# Access Compliance Report

## Public Rights-of-Way

Intersection ID: 25357	Main Street: RAINTREE_LN	Cross Street: WILLOW_POINT_DR	Location: SW
ADA ID: BA7B304190D8	Ramp Type: PerpDiag	Initial Pass/Fail: Fail	Overall Compliance: No
		Severity Score: 12.5

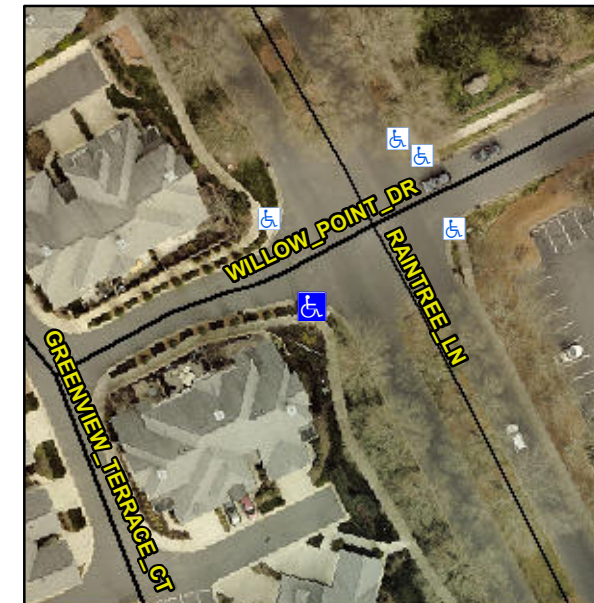
**Not Found, R304.2.2**

Compliance	Description	Data	Compliance	Description	Data
N/A	Ramp Length (in)	48.0	No	Ramp Slope (%)	8.8
Yes	Ramp Width (in)	48.0	Yes	Ramp XSlope (%)	1.7
N/A	Flare Type LT	N/A	N/A	Flare Type RT	N/A
N/A	Flare Slope LT (%)	N/A	N/A	Flare Slope RT (%)	N/A
N/A	Flare Traversable LT?	N/A	N/A	Flare Traversable RT?	N/A
N/A	Landing Length (in)	N/A	N/A	DWS Provided?	N/A
N/A	Landing Width (in)	N/A	N/A	DWS Contrast?	N/A
N/A	Landing Slope (%)	N/A	N/A	DWS Length (in)	N/A
N/A	Landing X Slope (%)	N/A	N/A	DWS Full Width?	N/A
N/A	Landing Curb? (Y/N)	N/A	N/A	DWS Offset (in)	N/A
N/A	Shared Landing?	N/A			
N/A	Gutter Ponding?	N/A	N/A	Gutter Slope (%)	N/A
N/A	Gutter Lip Ht (in)	N/A	N/A	Gutter X Slope (%)	N/A
N/A	Painted X Walk1?	No	N/A	Painted X Walk2?	No
	X Walk 1 Direction	To NE		X Walk 2 Direction	To NW
N/A	X Walk 1 Width (in)	N/A	N/A	X Walk 2 Width (in)	N/A
	X Walk 1 Slope (%)	2.4		X Walk 2 Slope (%)	0.5
	X Walk 1 X Slope (%)	1.5		X Walk 2 X Slope (%)	3.7

**Remove & Replace Curb Ramp With Two New Directional Ramps or Equivalent.**
